Kroger Field Repairs 2026

Lower Bowl Concrete & Waterproofing

ADDENDUM #2

Addendum No. 02

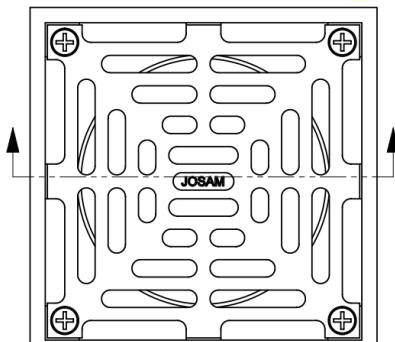
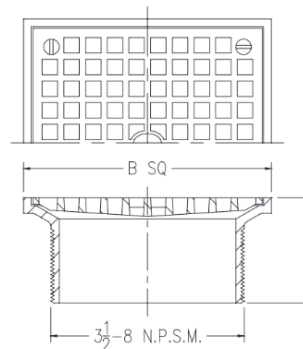
10. Question 10: The drains specified in some instances are not heel proof. Given that foot traffic will be going over top of these drains, what is the Engineer's recommendation?

It is our intention that all drain strainers are to be heel proof. See images below.

5S, 6S, 8S: SLOT WIDTH 1/4" (ADA AND **HEELPROOF**)

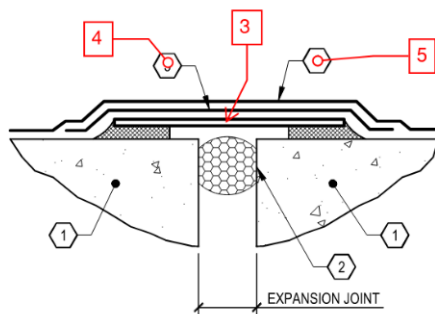
30. Question 30: Is the ground you are standing on when you go through the gate 4 entrance is slab on grade? I have no clue how to access the underside of the lower bowl for repairs if we can't have equipment over 2,000 lbs.

See Keynote 1 and 2 on Drawing 101 for the Main Concourse.

The 2,000-pound load restriction references a single concentrated point load on Ramp 4. Multiple point loads of this limit could be utilized for equipment if engineered and spread out per General Note C.1.d on Drawing 002. The Contractor is responsible for reviewing the structure and hiring an engineer as needed for equipment placement per General Note D.4 on Drawing 002.
